TOTALFLOW *Technical Bulletin* 83

Potential Problem with 6700 Flow Computer Charger Circuit

Version 1.0, Revision AA (24 March 2000)

Locations where the heat sink could come into contact with the CB-181 shield plate.

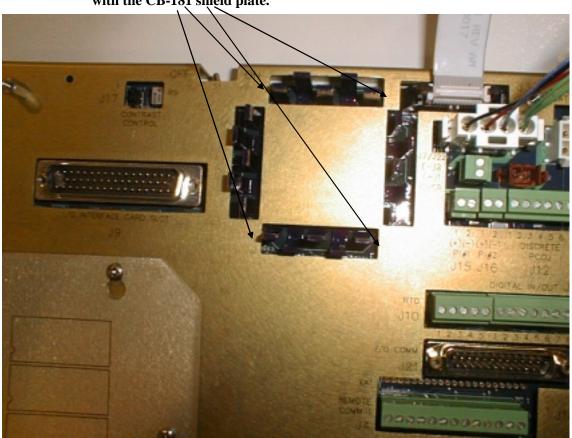
It was discovered that some number of shield plates were making contact with the electronic board's charger heat sink (see picture below). If contact is made between the shield and heat sink, the charger will short to ground. This shorted condition will keep the battery from charging. The symptom will be that the charger voltage will display around 8-9 volts DC instead of somewhere between 12-15 volts DC. The normal charging voltage should be slightly higher than the battery voltage, if charging. There will be periods of time that the charging voltage will read open circuit voltage (around 20 volts DC for solar panel). This is normal and indicates that the battery is fully charged.

To correct the problem, first disconnect the charger and then disconnect the main battery pack. Loosen the standoffs that secure the shield plate and then re-position the shield so that none of heat sink fins come into contact with the shield plate. Tighten the standoffs and finally re-connect the battery and then the re-connect the charger. Using a PCCU or PCCU laptop software, check the charging voltage and verify the voltage is equal to or higher than the battery voltage. If you have any questions concerning this bulletin call me at (918) 338-4819 or 1 (800) 442-3097 option 2, 2.
